SUBJECT: Savannah River Site's Responses to the Regulatory Comments on the Performance Evaluation Report (PER) for the A-Area Burning/Rubble Pits (731-A, -1A) and Rubble Pit (731-2A) and the Miscellaneous Chemical Basin/Metals Burning Pit (731-4A, -5A) Operable Unit (OU) - January through December 2016 (SRNS-RP-2017-00125, Revision 0, May 2017) CERCLIS Number: 28

**SRS Responses to U.S. Environmental Protection Agency's Comments on the Performance Evaluation Report (PER) for the A-Area Burning/Rubble Pits (731-A, -1A) and Rubble Pit (731-2A) and the Miscellaneous Chemical Basin/Metals Burning Pit (731-4A, -5A) Operable Unit, January through December 2016 (U), SRNS-RP-2017-00125, Revision 0, May 2017, CERCLIS Number: 28, Savannah River Site, Aiken, South Carolina
Comments Received: September 21, 2017**

**SRS Responses to South Carolina Department of Health and Environmental Control's
Comments on the Performance Evaluation Report (PER) for the A-Area Burning/Rubble
Pits (731-A, -1A) and Rubble Pit (731-2A) and the Miscellaneous Chemical Basin/Metals
Burning Pit (731-4A, -5A) Operable Unit, January through December 2016 (U),
SRNS-RP-2017-00125, Revision 0, May 2017, CERCLIS Number:

Figure 7. ABRP Phased SVE (Active) Well TCE Production Rates

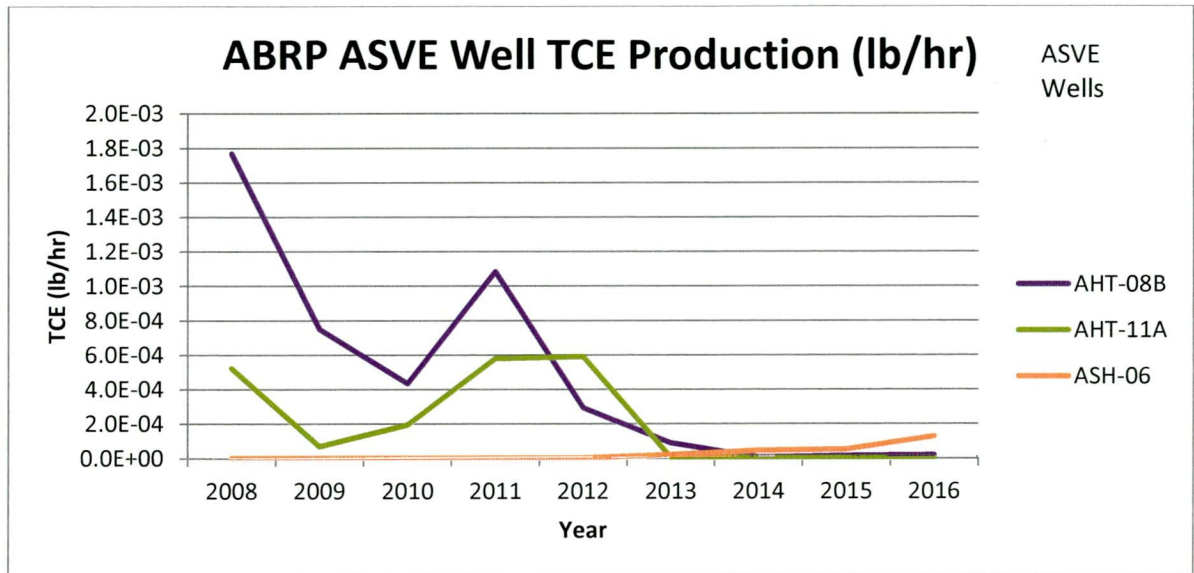
4. The fluctuations in TCE concentrations depicted on Figure 7 (ABRP Phased SVE [Active] Well TCE Production Rates) and Figure 9 (ABRP Phased SVE [Active] Well Exhaust Gas TCE Concentrations), are not easily discernable. Revise Figures 7 and 9 using a different scale so that the fluctuations in TCE concentrations are depicted in a way that can be more readily seen and useable.

Response: Clarification. The purpose of the figures is to show the large decrease in TCE production and well exhaust gas concentrations since the initial operation of the ASVE. In the next PER, Figures 7 and 9 will be revised to show only the current ASVE wells similar to the attached figures.
